SUNDRY NOTICES AND REPORTS ON WELLS (DO NOT USE THIS FORM FOR PROPOSALS TO DRILL OR TO DEEPEN OR PLUG BACK TO A DIFFERENT RESERVOIR. USE "APPLICATION FOR PERMIT" (FORM C-101) FOR SUCH PROPOSALS.) 1. Type of Well: Oil Well ☒ Gas Well ☐ Other ☐		WELL API NO. 30-025-54508
2. Name of Operator EOG RESOURCES, INC		5. Indicate Type of Lease STATE ☒ FEE ☐
3. Address of Operator P.O. BOX 2267, MIDLAND, TEXAS, 79702		6. State Oil & Gas Lease No.
4. Well Location Unit Letter _____ M _____ : _____ 938 _____ feet from the _____ SOUTH _____ line and _____ 848 _____ feet from the _____ WEST _____ line Section 14 Township 21S Range 33E NMPM County LEA		7. Lease Name or Unit Agreement Name DATE 14 STATE COM
11. Elevation (Show whether DR, RKB, RT, GR, etc.) 3814' GR		8. Well Number 604H
9. OGRID Number 7377		10. Pool name or Wildcat 5535 BERRY; BONE SPRING, NORTH

EOG respectfully requests an amendment to our approved APD for this well to reflect the following changes:

Update casing and cement program to current design.

Operator: EOG RESOURCES INC 5509 Champions Drive Midland, TX 79706	OGRID: 7377
	Action Number: 519695
	Action Type: [C-103] NOI Change of Plans (C-103A)

[Figure E] 4 String – Uncemented Annulus between 2nd Intermediate and Production Casing Strings

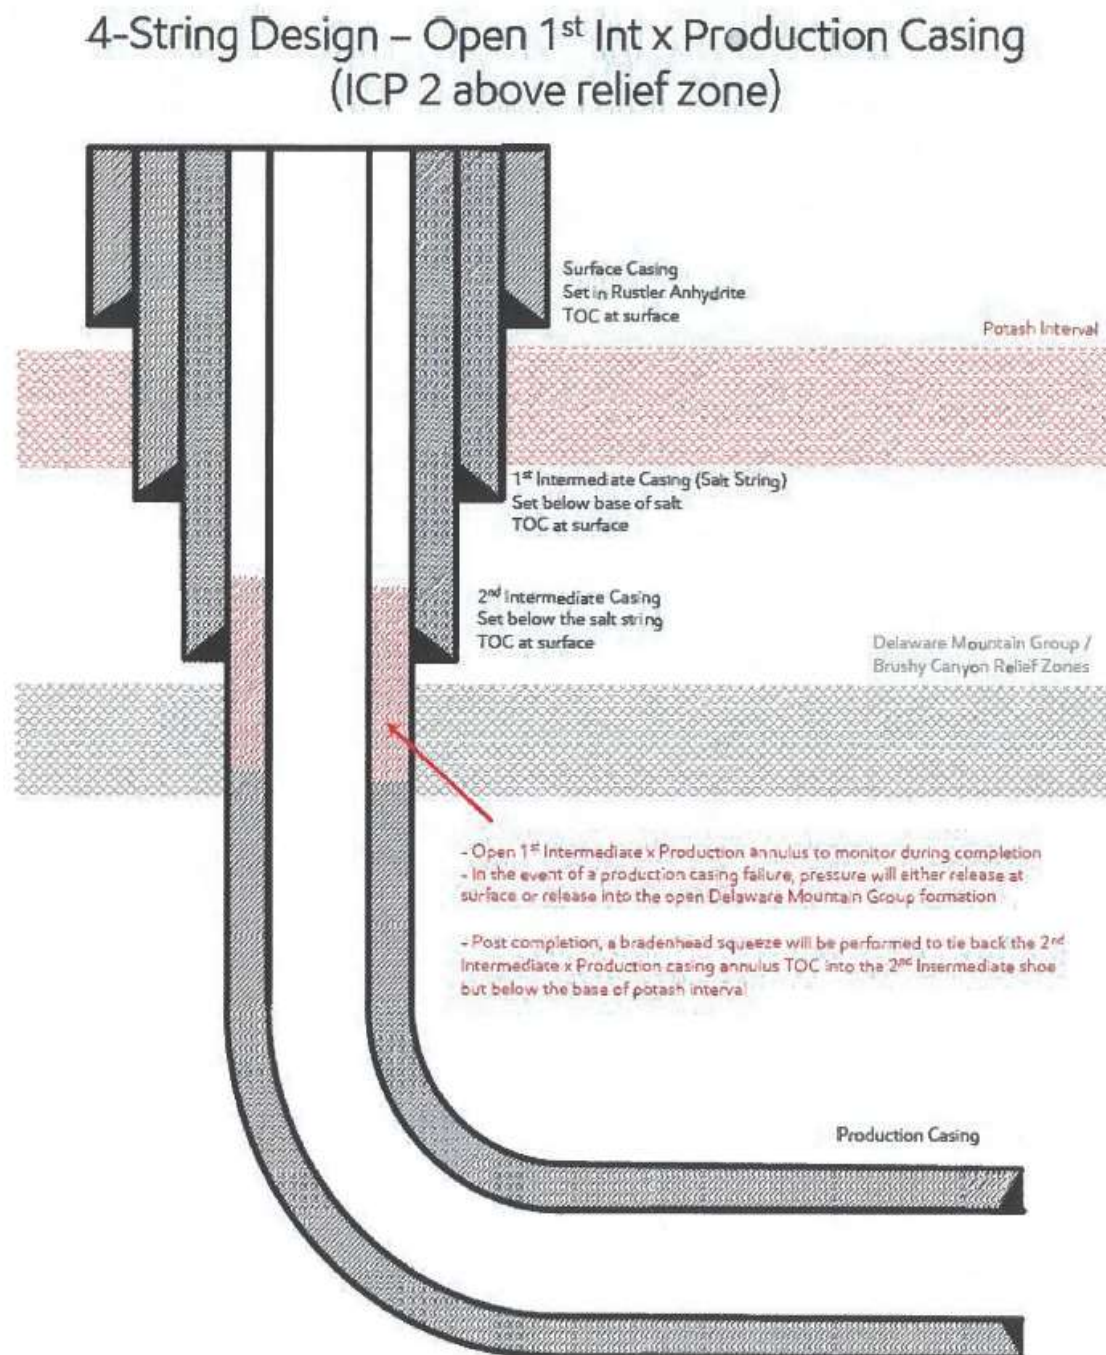
See Attached Figure E from R-111-Q for 4 String - Uncemented Annulus WBD.

EOG will incorporate method C(5)(c)(iii) for the 4 string designs, leaving the annulus between the 2nd intermediate and the production string open and monitored. The top of production cement will be at least 500 ft below the 2nd intermediate casing point, and ZERO EXCESS will be pumped to ensure no tie-back into the 2nd intermediate.

After hydraulic fracturing operations have been concluded/no more than 180 days after the well is brought online, EOG will bradenhead cement to ensure at least 500 ft of tie-back inside the 2nd intermediate casing, but not higher than USGS Marker Bed No. 126., and at least 50' above the Capitan formation.

[Figure D] 4 String – Uncemented annulus between 1st and 2nd Intermediate casing strings

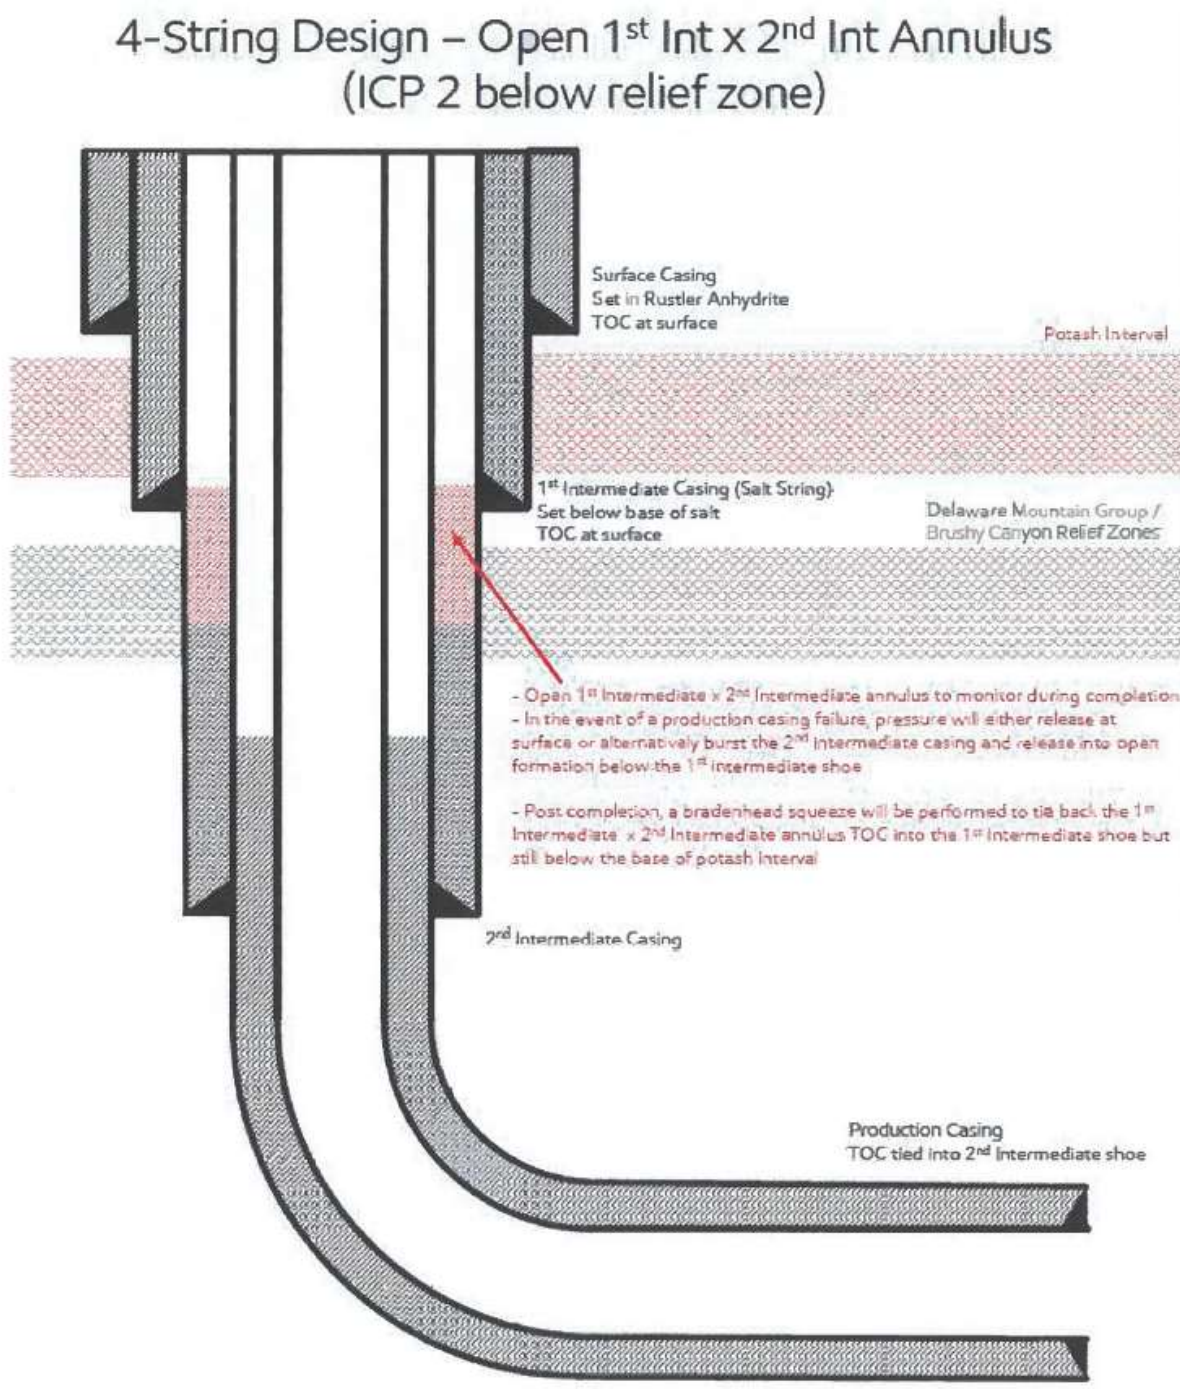
See Attached Figure D from R-111-Q. This design will be modified for EOG's 5 string designs, where the annulus between the 3rd and 2nd intermediate casings will be left open below the 2nd intermediate casing shoe.

Created By	Comment	Comment Date
matthew.gomez	For future reference, please do not include other R-111-Q designs that are not intended to be utilized.	11/18/2025

EOG will incorporate a modified method C(5)(c)(ii) for the 5 string designs, leaving the annulus between the 2nd and 3rd intermediates open and monitored. The top of the 3rd intermediate cement will be at least 500 ft below the 2nd intermediate casing point, and ZERO EXCESS will be pumped to ensure no tie-back into the 2nd

After hydraulic fracturing operations have been concluded/no more than 180 days after the well is brought online, EOG will bradenhead cement to ensure at least 500 ft of tie-back between the 3rd and the 2nd intermediate casings, but not higher than USGS Marker Bed No. 126, and at least 50' above the Capitan formation.
